Access Compliance Report Public Rights-of-Way (Curb Ramps)

Main Street: N/A Cross Street: TIERNO_RD Location: W

ADA ID: RPRK211129125447 Ramp Type: Type 4 - Parallel Initial Pass/Fail: Pass Overall Compliance: No Severity Score: 6

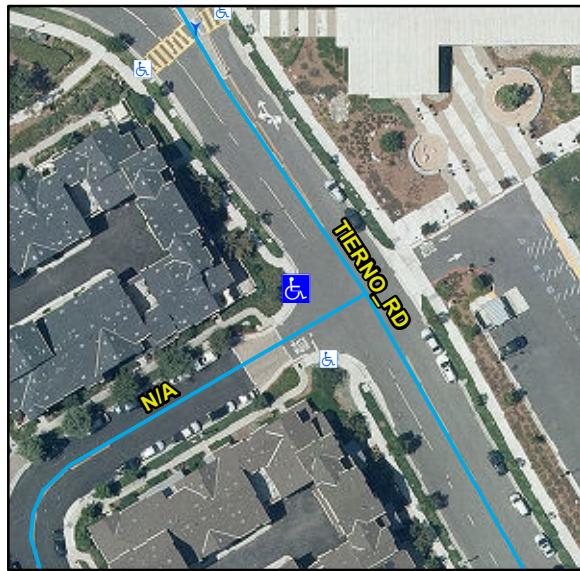
Remove & Replace Landing. Remove & Replace Gutter.

R304.5.3, R304.5.4, STD 1115
